# Outer Dowsing Offshore Wind

## The Applicant's Responses to Relevant Representations

Document Reference: 15.3

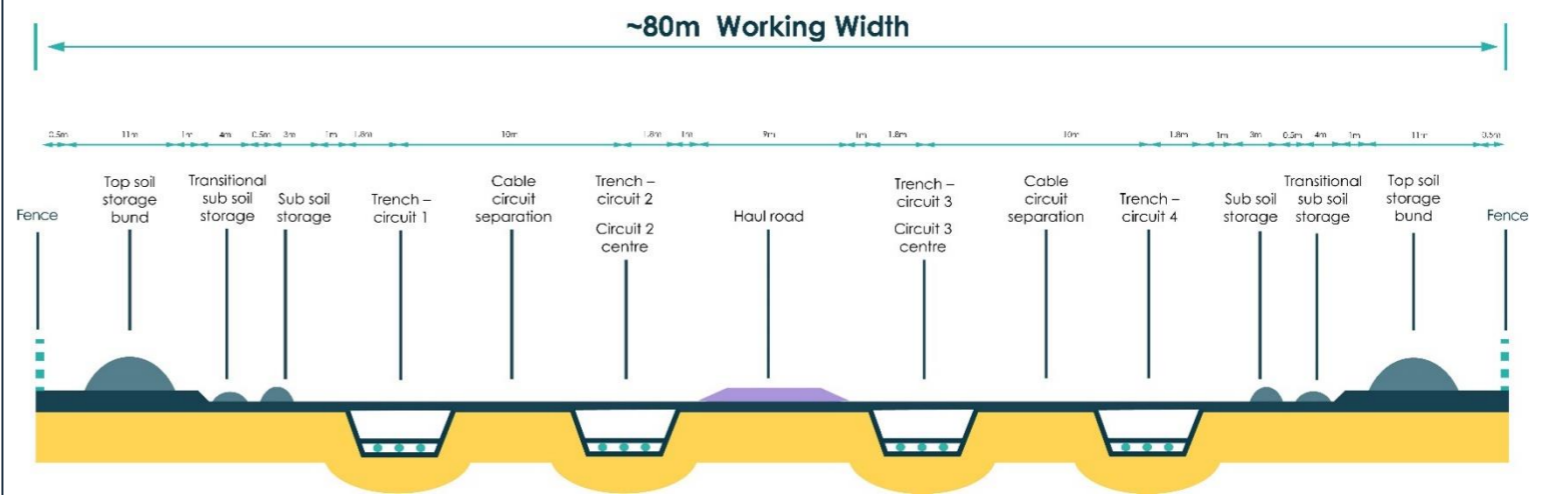
No explanation is given in the Cable Statement as to why a typical 'working width' of approximately 80m (wider at crossings) is required. Paragraph 43 of Chapter 3 (Project Description) of the Environmental Statement ("ES") (ODOW Application Document 6.1.3) summarises the physical infrastructure that will be constructed within the onshore ECC/'working width' and states that:

Plate 8.1 (extracted and included below) comprises a cross sectional schematic/drawing of an example 'working width' for four cable circuits. [NB: Plate 8.1 cannot be included in online form- a letter version of this Relevant Representation has been provided by e-mail which includes drawings, photographs.] Given that Plate 8.1 is provided as an example, it is not clear if the Project 'working width' will definitely be laid out in this manner. Assuming it were, and based on the ODOW submission, it would comprise the following elements:

The Applicant notes that plate/figure 8.1 is indicative and does not contain all parameters considered when assessing the requirement for the 80m typical working width. With this response, the applicant submits an updated cross-section outlining all components of the 80m corridor (based on four circuits being installed by an open cut methodology).
